HUGHES SERVICE INFORMATION NOTICE

NOTICE NO. N-37.2*

SUBJECT: RETIREMENT - BELLCRANK ASSEMBLY, LATERAL
PITCH MIXER IDLER (P/N269A7506)

MODELS AFFECTED: { 269A Helicopter Serial Nos. 0011 through 1033
269A-1 Helicopter Serial Nos. 0001 through 0041
269B Helicopter Serial Nos. 0001 through 0398

FIGURE 1. INSPECTION - 269A7506 LATERAL PITCH MIXER IDLER BELLCRANK ASSEMBLY

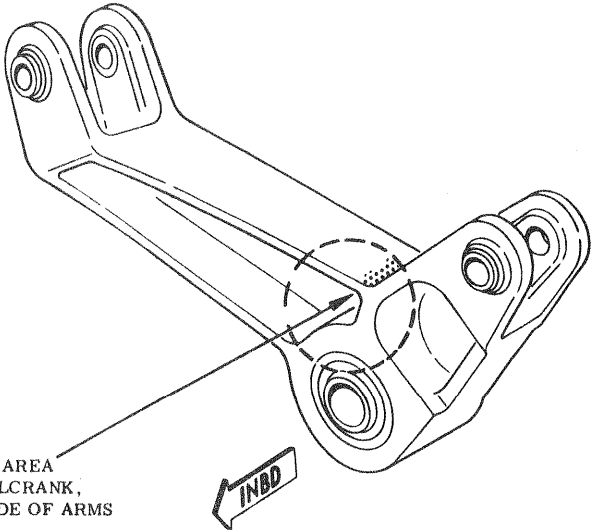
If inspection reveals damage, deformation or cracks, replace bellcrank assembly with new P/N269A7508 bellcrank assembly per Step I. Pay particular attention to junction of bellcrank arms, on inboard side of arms (See Figure 1).

APEX AREA
OF BELLCRANK,
INBOARD SIDE OF ARMS
